SERVICE BULLETIN NO. 290

November 25, 1968

SUBJECT: A75 BSA Maintenance Handbook

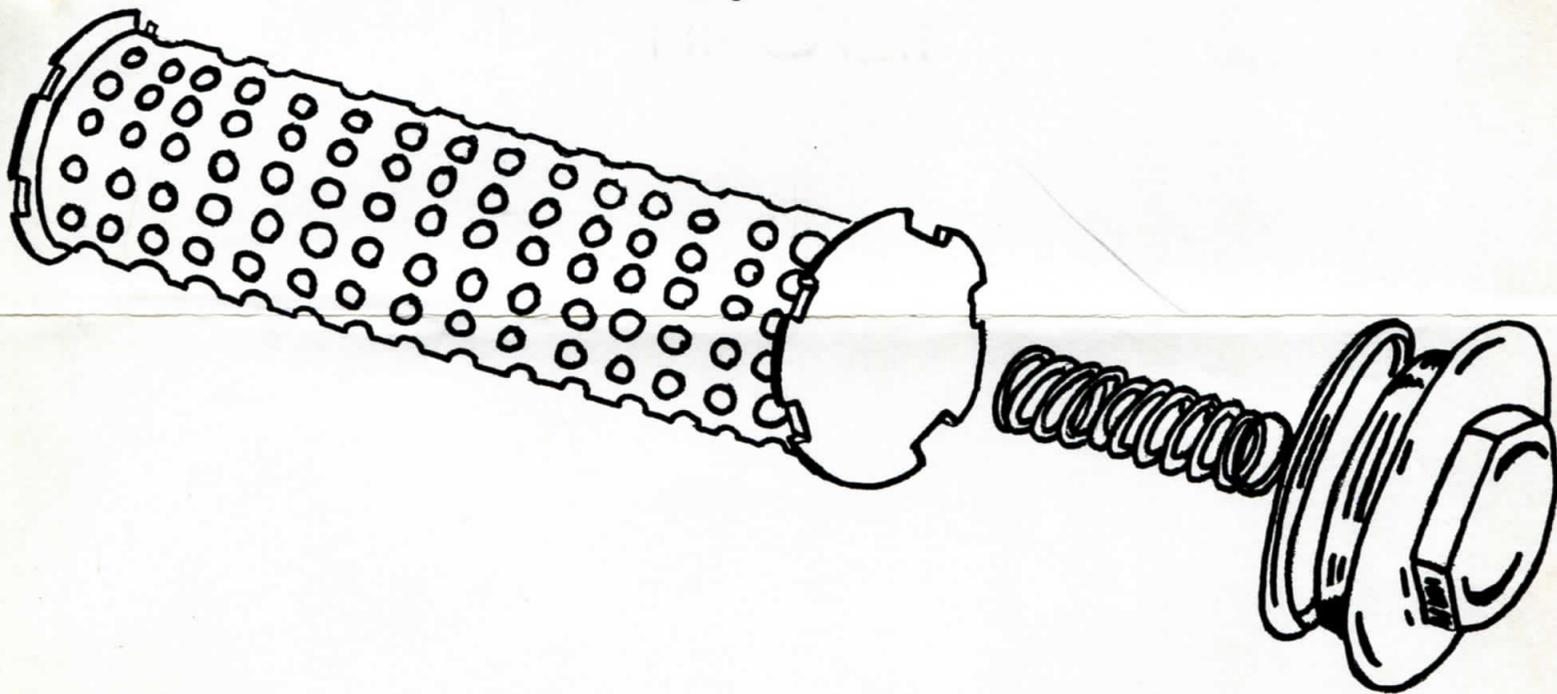
On certain early printings of the Rocket 3 Maintenance Handbook, Page 14, which are packed with the motorcycles, the illustration showing the fitting of the oil filter cartridge is incorrect.

The illustration below shows the correct manner in which to fit the oil filter cartridge.
